Westmead Catholic Community Education Campus Modification 1

State Significant Development Modification Assessment
(SSD-10383-Mod-1)

September 2023

Published by the NSW Department of Planning and Environment

Figure 5 | Existing lot boundaries (top left) and proposed Lot boundaries (top right) (Base source Applicant's RtS 2023)

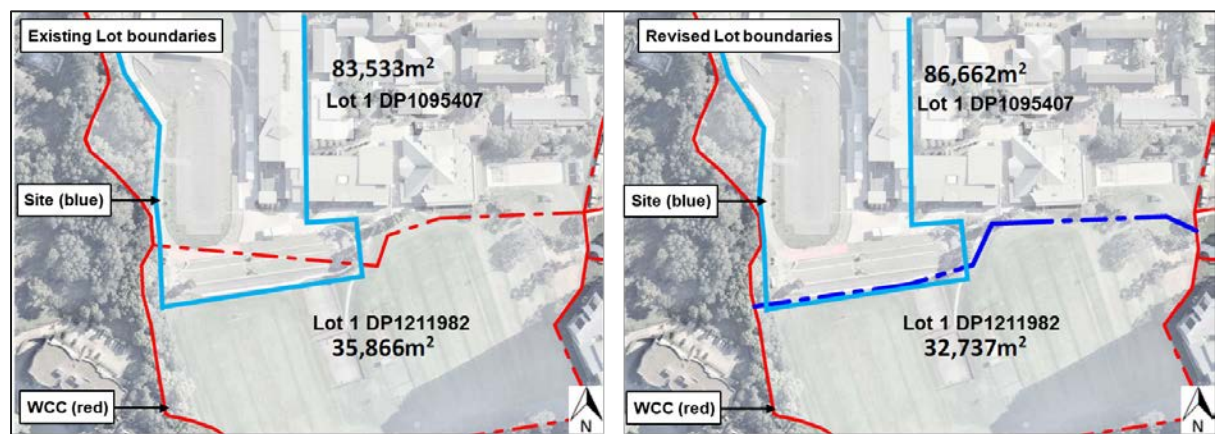
- remove the requirement to establish easements on or off the site, to facilitate protection of the through site pedestrian link in condition B1
 - in lieu of the easement creation, adjust internal lot boundaries so that the future through site pedestrian link is located wholly within the Lot 1 DP1095407 (the northern lot) (**Figure 5**).

The Applicant has stated the boundary realignment would ensure the future through site pedestrian link required by condition B1 is wholly contained within Lot 1 DP1095407 (the northern lot) (**Figure 5**). In addition, students would continue to have access to the link if the southern lot is sold in the future.

The Applicant has also indicated that the boundary adjustment would be achieved by registering a 'Plan of Identification' at NSW Registry Services. In addition, development consent is not required for this kind of boundary adjustment process as it not defined as 'subdivision' under the EP&A Act.

The Department considers that the Applicant's justification to remove the requirement for easement contradicts its request to amend the design of the link in condition B1(a), and does not support the

- the link route is uncertain (as noted by the Applicant) and imposing a condition requiring the only solution to be via a boundary adjustment would be premature and irrelevant
- boundary adjustment did not form a part of the original application, and is not within the scope of the modification application. As such, required boundary adjustment can be completed under a separate planning pathway and the condition can still be achieved
- the boundary adjustment assumes a specific through site pedestrian link location / route, which is contrary to the Applicant's assertion that the pathway for the through site pedestrian link has not been finalised
- it would be inappropriate to secure any boundary adjustment via condition as:
 - the adjustment impacts multiple owners and no owner agreements have been provided
 - it has not been formally consulted or a planning pathway ascertained.

The Department concludes that condition E4(c) should not be amended as proposed by the Applicant and the requirements of condition E4(c) to establish appropriate easement(s) / covenant(s) be retained in full, unless the Applicant can provide satisfactory evidence that an easement and/or positive covenants are not required, which is reflected in the amended condition E4(d) (see **Section 6.2.2**).

Figure 6 | Approved (left) and proposed (right) ground floor landscaping layout and design (Base source Applicant's RtS 2023)

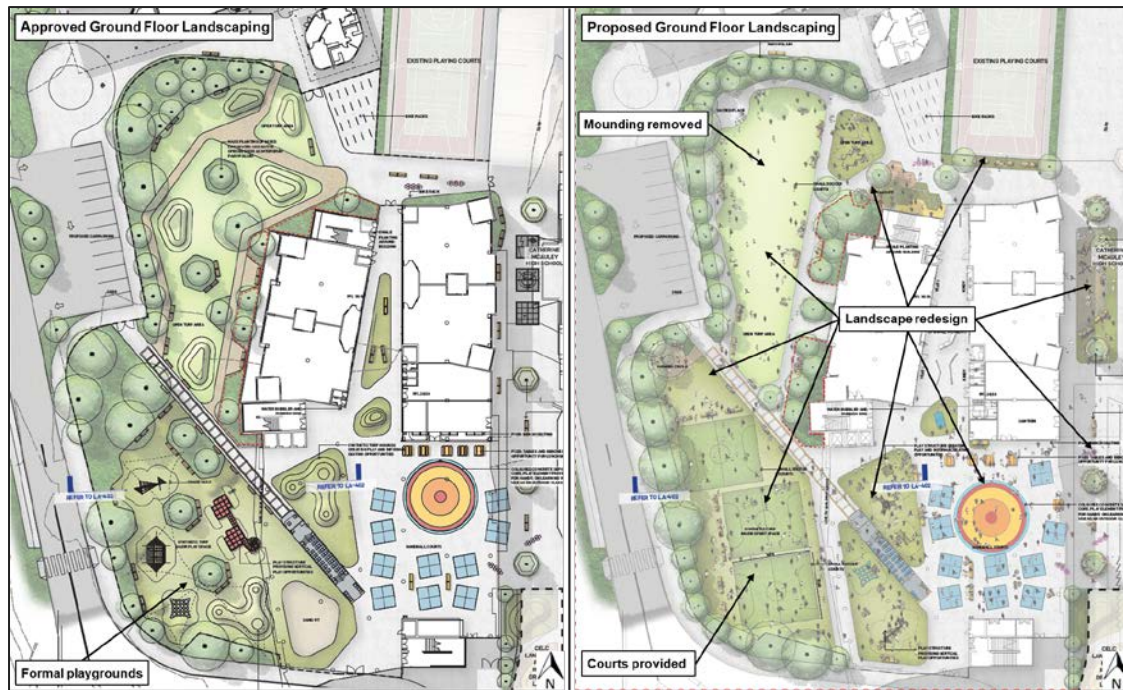
The key changes to landscaping design and layout occur at ground and roof (Level 5) levels, discussed below and shown at **Figure 6** and **Figure 7**. A comparison is provided between the approved / proposed landscape and open space areas at **Table 1**:

- relocate the formal playground structures from the south-west of the site to the weather protected undercroft, and replace with three small synthetic soccer pitches
- remove mounded landscaping and mass plantings from the north-west of the site, and replace with open grassed areas for active recreation
- other minor changes the approved landscape design, footpath and furniture layouts
- increase the number of trees from 43 to 50.

- replace a lined multi-sports court with two small synthetic soccer pitches
- replace some passive play areas with more active play areas
- remove the covered walkway and provide a pavilion for covered play
- relocate toilets and redesign the running track
- reduce the total number of trees at this level from 11 to four.

The proposed amendments result in an overall increase in unencumbered open space (+401m²), active areas (+576m²) and quantum of open space per child (+0.3m²). There is no change to the total number of proposed trees to be removed or replaced.

The Department has considered the proposed modification of landscape and open space and considers the changes are acceptable as:

Figure 10 | Original Application TAIA Figure 6.6 dated 25 August 2021 (Base source: SSD 10383)

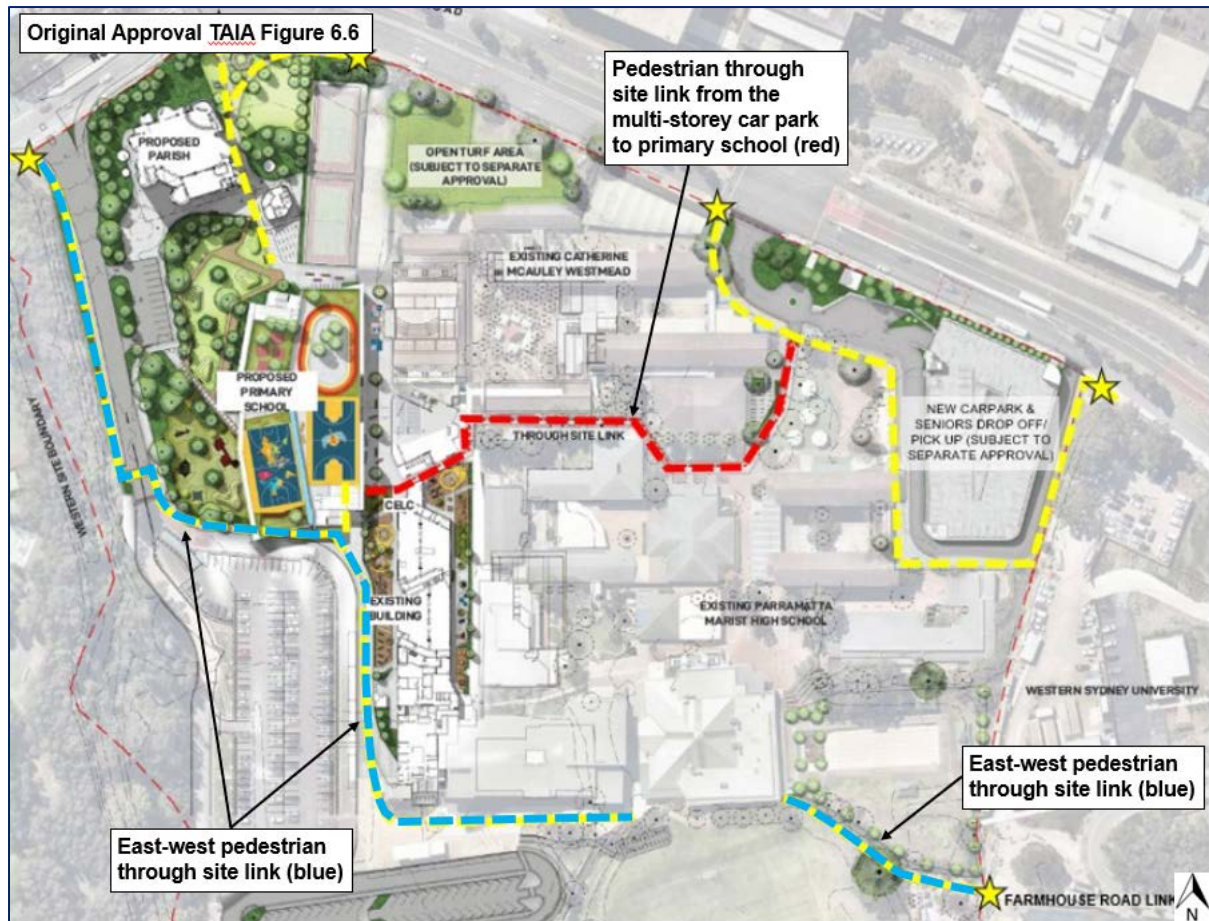
The modification (as amended by the RtS) proposes to amend condition B1(a) by changing the destination of the schematic through site pedestrian link from its delivery all the way through to the 'western boundary' to it being delivered to the 'primary school', broadening users of the link to include staff and school users, but deleting reference to **Figure 6.6** and the GTP, as outlined at **Table 2**.

- the link's purpose is to provide an alternative student access to Darcy Road. It is therefore unnecessary for the link be extended to the western boundary (beyond the school) at this time
- approval was for a primary school, and any new paths should be for the purpose of the school
- the pedestrian link would be used by all school users, not just students. Therefore, it is necessary to include reference to staff, Catholic Schools and Catholic Education Learning Centre (CELC)
- the condition requires consistency with Figure 6.6 of the TAIA, which specifies a precise route for the link from Farmhouse Road to the western boundary of the site. However, the link route has not been designed or finalised. To ensure the most appropriate link is provided, flexibility is required, and the link route should not be precisely defined at this stage
- the reference to the GTP is superfluous.

The Department supports the deletion of the reference to Figure 6.6 to allow flexibility in the design of the pedestrian link route as:

- the precise location and design of the link has not been finalised at this stage
- requiring a precise link route at this stage could jeopardise the provision of the best route for the development
- Figure 6.6 shows a pedestrian link route through to the western boundary of the site, which is not consistent with the proposal as modified.

Figure 11 | Location of key school entries (Base source: Applicant's RtS 2023)

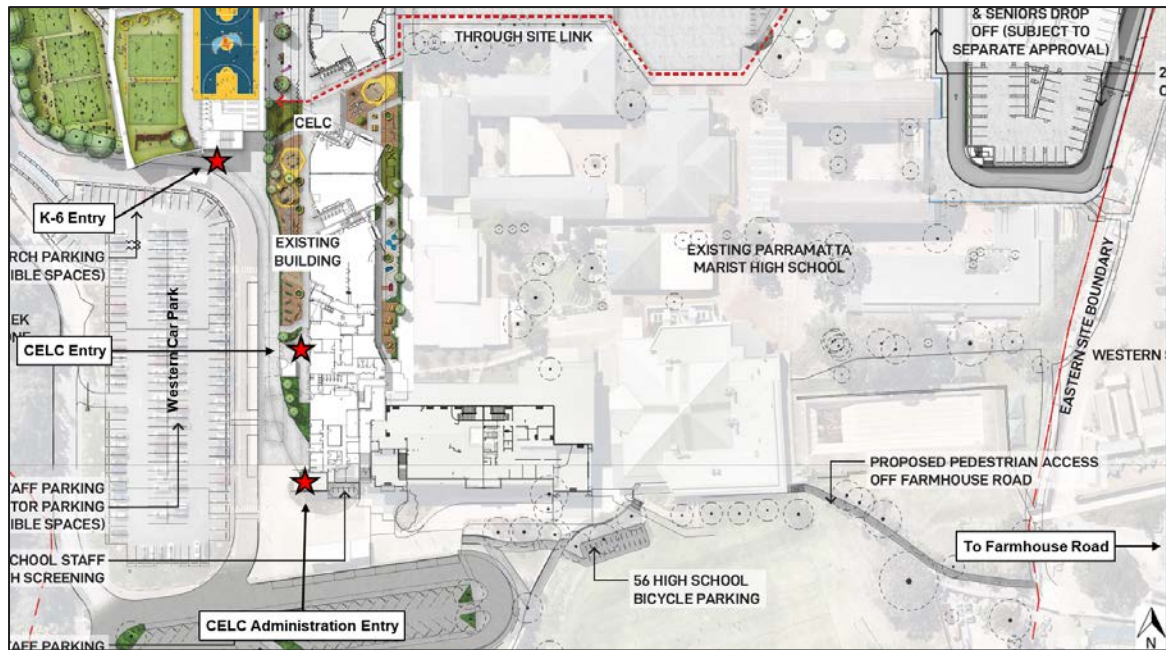
Council did not support the rewording of 'western boundary of the site' with 'primary school' in the RtS. Council did not object to the deletion of the reference to GTP.

The Department notes Council's concerns with proposed rewording. However, after consideration, the Department notes the Commission's original intent of the condition was to require public access through the WCC site in the future, as part of the staged delivery of the Master Plan for the WCC site. Therefore, the Department considers it logical and reasonable that the link terminates at the main school entry adjacent to the western car park as shown at **Figure 11**.

The Department therefore recommends the condition be reworded, to require the destination of the through site pedestrian link be changed from the 'western boundary of the site' to the 'K-6 school entry, passing the CELC administration and CELC entries fronting the western car parking area'.
